NATIONAL DAM INSPECTION PROGRAM. NORTH LAKE DAM

PENNSYLVANIA
NORTH LAKE DAM

NDI I.D. NO. PA-00268,
PENNDER I.D. NO. 52-180

PHASE I INSPECTION REPORT,
NATIONAL DAM INSPECTION PROGRAM

NORTH LAKE DAM
GENERAL PLAN - FIELD INSPECTION NOTES

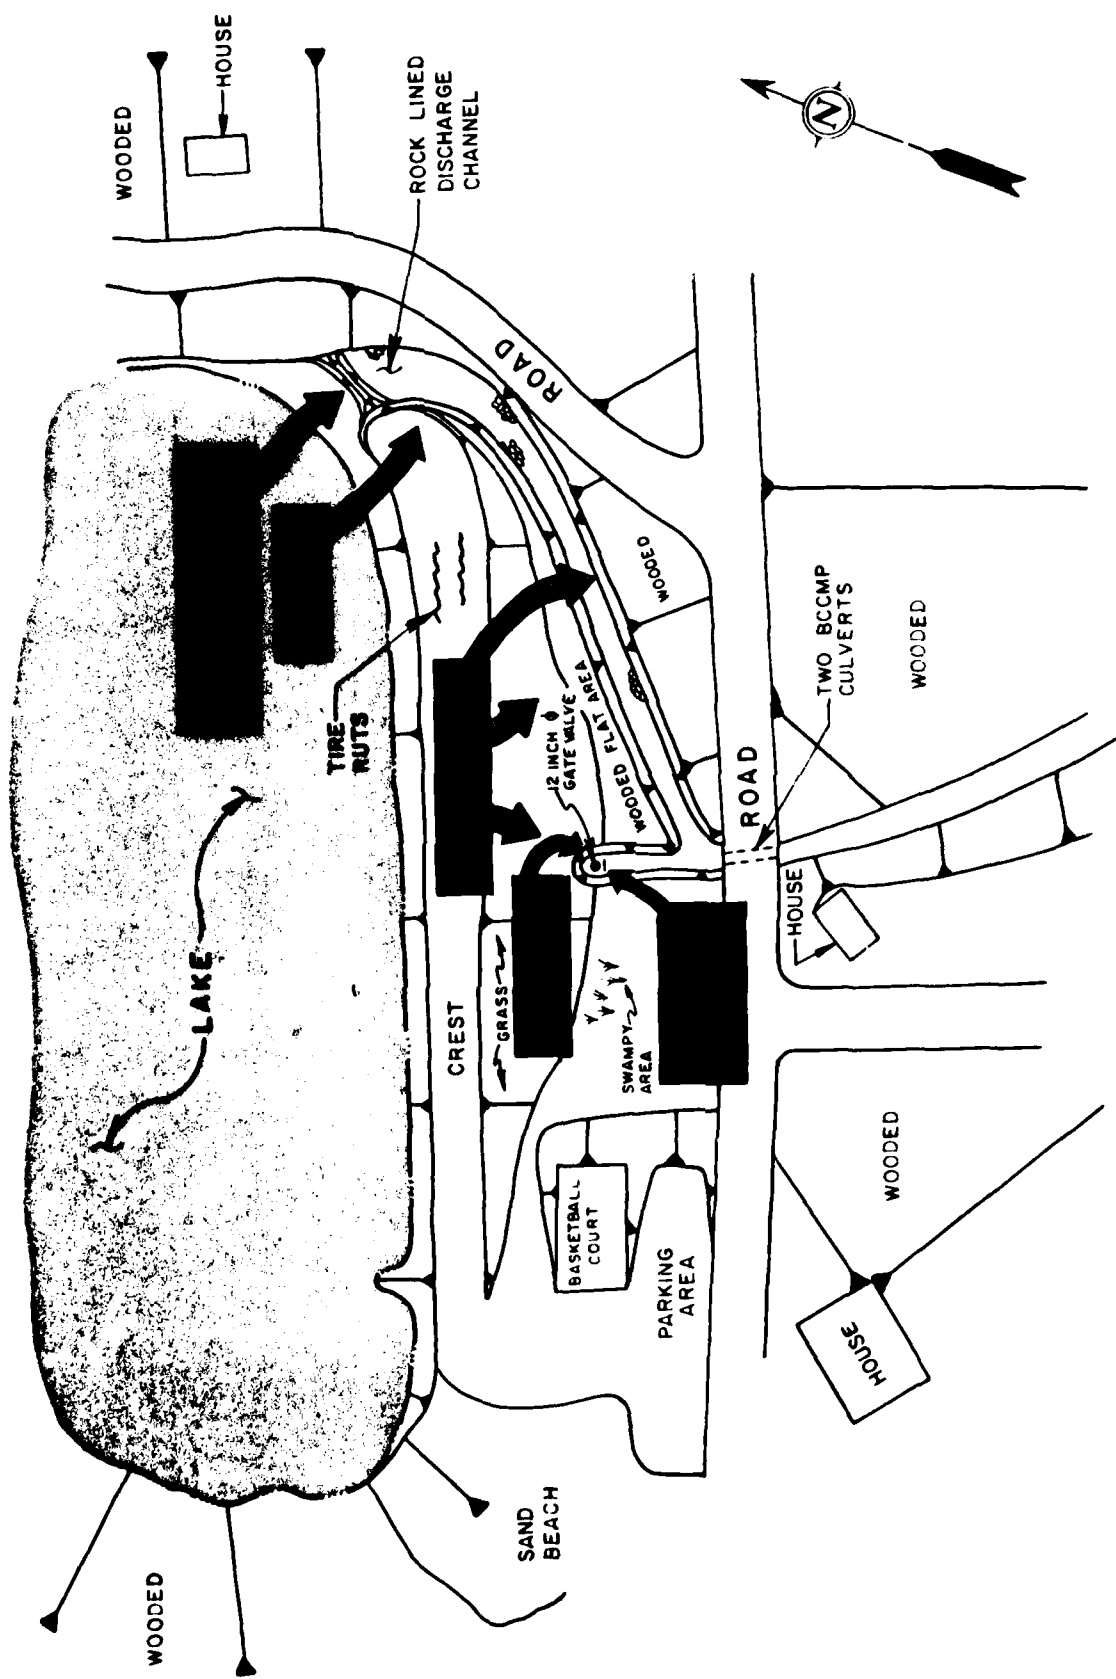
b. Embankment. Observations made during the visual inspection indicate the embankment is in fair condition, but in need of general maintenance. No evidence of seepage through the downstream embankment face, sloughing, erosion or animal burrows was observed. The embankment crest is noticeably low (in excess of 1-foot) near the spillway relative to the remainder of the crest. About two-thirds of the embankment is overgrown along an area extending approximately 400 feet to the right of the spillway. The vegetation is characterized as primarily brush and high weeds with clumps of small trees strewn throughout (see Photographs 2 and 3). In contrast, much of the embankment crest and upstream face are bare and unprotected with only light vegetation visible (see Photographs 2 and 4). Several long tire ruts scar the crest near the spillway. A small area characterized by swamplike vegetation is located about 350 to 375 feet from the right abutment along the downstream embankment toe. Seepage was observed at the downstream embankment toe near the outlet conduit flowing at a rate of about two to three gpm (see Photograph 8). The flow is suspected of being either seepage through the embankment foundation, or perhaps drainage from a concealed toe drain. A precise assessment of the condition is difficult without adequate design data and drawings.

1. Spillway. The spillway is considered to be in poor condition. Efforts to raise the pool level by placing a small earth and rock dike across the channel entrance has resulted in a substantial reduction of the discharge capacity of the channel. The channel is apparently founded in rock as evidenced by the large boulders visible in the discharge channel (see Photograph 6); however, it is poorly defined with non-uniform side slopes. The right spillway wall appears to be formed by the embankment and is not adequately protected. Rock is scattered along the discharge channel, but does not appear to have been formally placed and probably provides only minimal erosion protection. The portion of the discharge channel that parallels the downstream embankment toe is heavily overgrown with brush and small trees that could potentially obstruct flow.

a. Remove the earth and rock dike from the spillway channel entrance in order to provide for maximum unobstructed flow. In addition, excess vegetation should be cleared from along the spillway discharge channel that parallels the downstream embankment toe.

b. Provide interim adequate erosion protection along the spillway right sidewall adjacent the embankment, as well as, along

the crest and slopes of the low portion of the embankment immediately to the right of the spillway until a more formal spillway assessment is completed.

CONTROL SECTION:

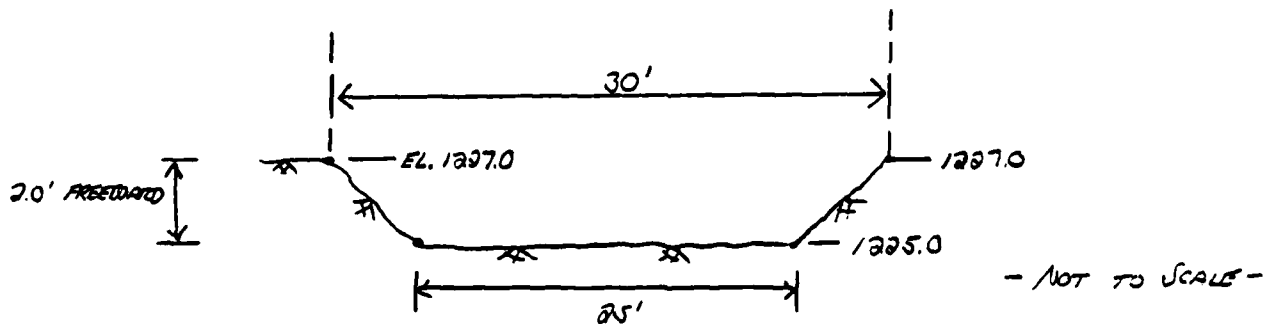
THE SPILLWAY CONSISTS OF AN UNCONTROLLED, ROUGHLY TRAPEZOIDAL CHANNEL CUT THROUGH SOIL AND ROCK AT THE LEFT ABUTMENT. AT THE TIME OF INSPECTION, THERE WAS A SMALL EARTH AND ROCK DIKE CONSTRUCTED ACROSS THE SPILLWAY CHANNEL, FOR THE PURPOSE OF RAISING THE RESERVOIR LEVEL. IT WILL BE ASSUMED IN THE SPILLWAY COMPUTATIONS THAT THE SMALL DIKE IS REMOVED (THE AVAILABLE FREEBOARD WITH THE DIKE IN PLACE IS ONLY 0.2 FT, RESULTING IN A GREATLY REDUCED SPILLWAY CAPACITY).
